#### 3.4.5 Pre-Application Submission October 2019

The proposals were revised further following a meeting with London Borough of Camden on 16th of October 2019 in response to proposals submitted in August 2019:

#### Key considerations - L.B.C. Comments on Pre-app and SGA Response

### Axonometric 4

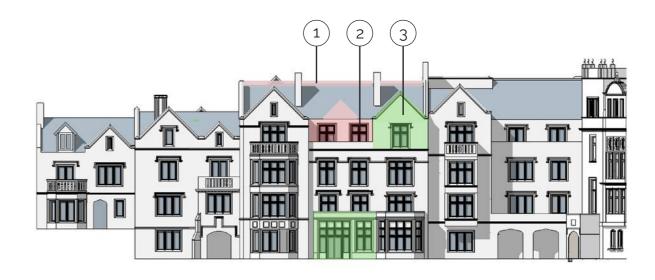
- L.B.C. Comment: Irrespective of architectural approach, as raised in the last pre-application meeting, there are concerns that the new building detracts from the prominence of the Edwardian building when viewed from the front of the site.

- d) Introduction of bays, arcades and lower volumes of bays of varying height to modulate and lower the scale of the new building.
- L.B.C. Comment: The proposed massing results in visual competition between the main house and the new extension.

- L.B.C. Comment: The proposal reads as one large singular, muscular building.
- SGA Response The reductive and accretional massing gradually lowered towards the entry lodge
  and modulation to the façade between 4 different buildings are arranged in an informal composition
  this breaks up the massing of the brief of the residential units into constituent architectural elements
  that are arranged in buildings that come together in the tradition of picturesque composition that
  characterises much of the building in the local area.

- SGA Response The composition of volumes and the façade treatment endeavours to maintain and enhance the prominence of the Edwardian building by:
  - a) Omission of the attic floor dormers and lower height of the proposed buildings to decrease its perceived height.

- b) Set back of upper (3rd) floor and the building adjacent to the new Tower.
  - c) Introduce the Tower as a scale mediator between the old and new buildings.

- SGA Response The siting and route into the development is such that the 'Frontal' approach to the
  existing building is maintained. Key views of the approach demonstrated that the new development
  in oblique, perspective view on approach. Distant views from the East clearly show the prominence
  of the existing building with its formal composition against the informal 'vernacular' style of the
  new building.
